Access Compliance Report

Public Rights-of-Way

(Curb Ramps)

Intersection ID: 2596	Main Street: FAIRVISTA_DR	Cross Street: KNIGHTSGATE_CT	Location: SW
ADA ID: 2FC676BACBF6	Ramp Type: PerpDiag	Initial Pass/Fail: Fail	Overall Compliance: No
Severity Score: 25			
Codes/Mitigation Info/Possible Solution		Field Measurements/Component Compliance

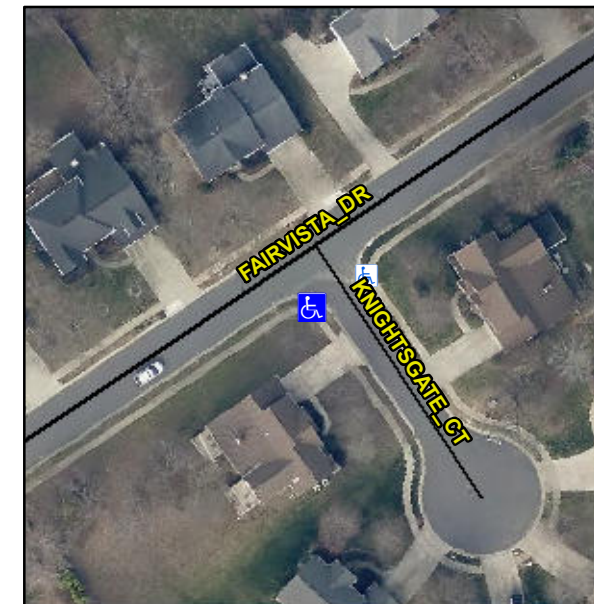
Not Found, R304.2.2, R304.5.3

Compliance	Description	Data	Compliance	Description	Data
N/A	Ramp Length (in)	47.0	No	Ramp Slope (%)	9.3
Yes	Ramp Width (in)	48.0	No	Ramp XSlope (%)	5.1
N/A	Flare Type LT	N/A	N/A	Flare Type RT	N/A
N/A	Flare Slope LT (%)	N/A	N/A	Flare Slope RT (%)	N/A
N/A	Flare Traversable LT?	N/A	N/A	Flare Traversable RT?	N/A
N/A	Landing Length (in)	N/A	N/A	DWS Provided?	N/A
N/A	Landing Width (in)	N/A	N/A	DWS Contrast?	N/A
N/A	Landing Slope (%)	N/A	N/A	DWS Length (in)	N/A
N/A	Landing X Slope (%)	N/A	N/A	DWS Full Width?	N/A
N/A	Landing Curb? (Y/N)	N/A	N/A	DWS Offset (in)	N/A
N/A	Shared Landing?	N/A			
N/A	Gutter Ponding?	N/A	N/A	Gutter Slope (%)	N/A
N/A	Gutter Lip Ht (in)	N/A	N/A	Gutter X Slope (%)	N/A
N/A	Painted X Walk1?	No	N/A	Painted X Walk2?	No
	X Walk 1 Direction	To E		X Walk 2 Direction	To NW
N/A	X Walk 1 Width (in)	N/A	N/A	X Walk 2 Width (in)	N/A
	X Walk 1 Slope (%)	5.4		X Walk 2 Slope (%)	3.3
	X Walk 1 X Slope (%)	3.7		X Walk 2 X Slope (%)	5.0

Remove & Replace Curb Ramp With Two New Directional Ramps or Equivalent.
